SIB 34 07 24

RECALL 24V-739: INTEGRATED BRAKE SYSTEM (IB)

This Service Information Bulletin (Revision 5) replaces SI B34 07 24 **dated April 2025**.

- Procedure revised

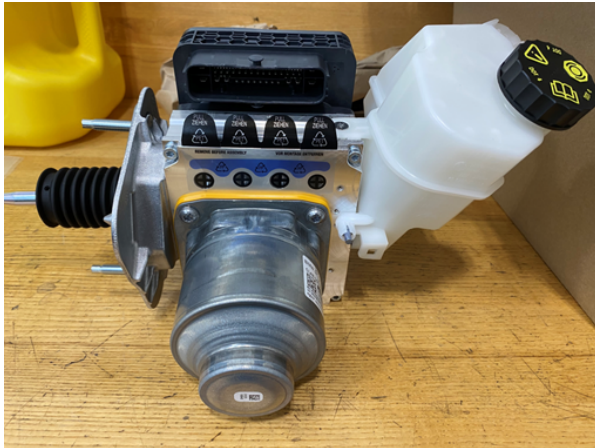
Replace the IB with either a “wet” pre-filled unit or a “dry” unfilled unit.

“Wet” IB pre-filled: Brake fluid reservoir is filled (arrow) and brake fluid line ports are plugged with bolts (circled).

“Dry” IB unfilled: Brake fluid reservoir is empty; brake fluid line ports are sealed with labels.
